EHX 9 Series Dry Mute Mod

How to Make The EFFECT Output Behave Properly

Early Revisions

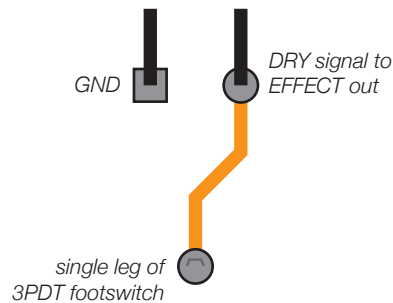
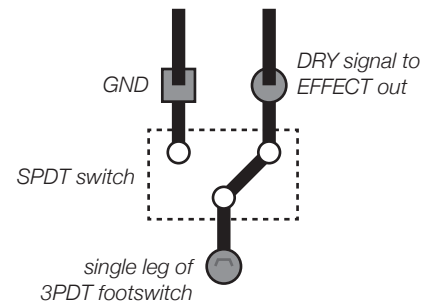
If you have tried using *both* output jacks on an early revision EHX 9 Series pedal, you know that the footswitch unhelpfully toggles the EFFECT output between a WET+DRY blend and just DRY. This renders the footswitch useless in real world applications. Follow the diagrams below to make the footswitch function the way it should (and was fixed in later revisions of the pedals).

the mod happens here

DRY MUTE switch included

Basic Mod

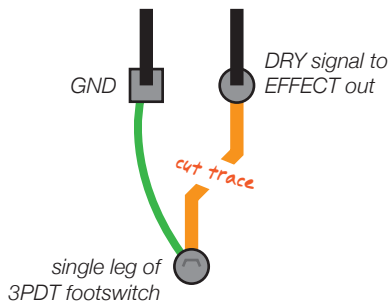
a simple permanent dry mute

Intermediate Mod

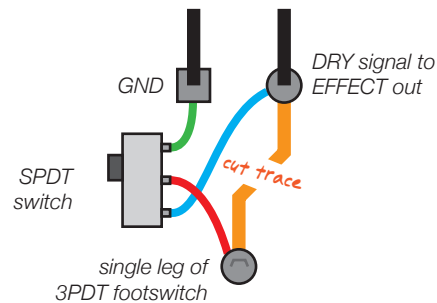
install a SPDT switch like later revisions

Advanced Mod

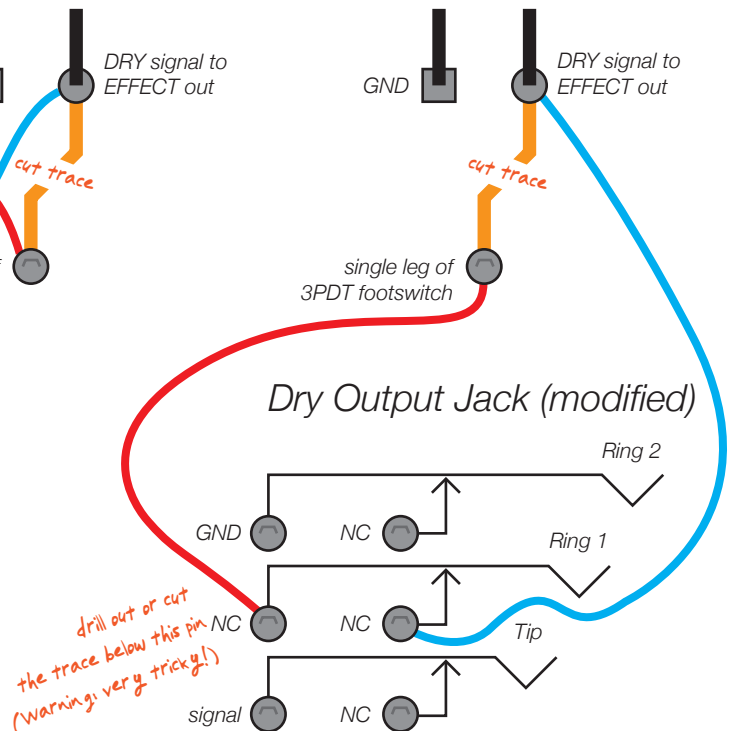
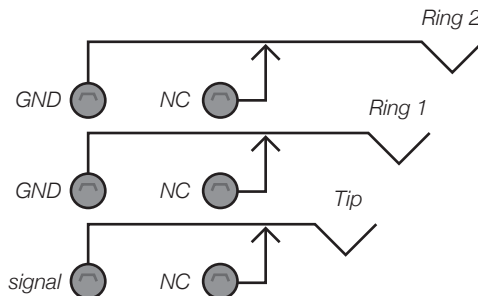
make the DRY output jack act as the switch
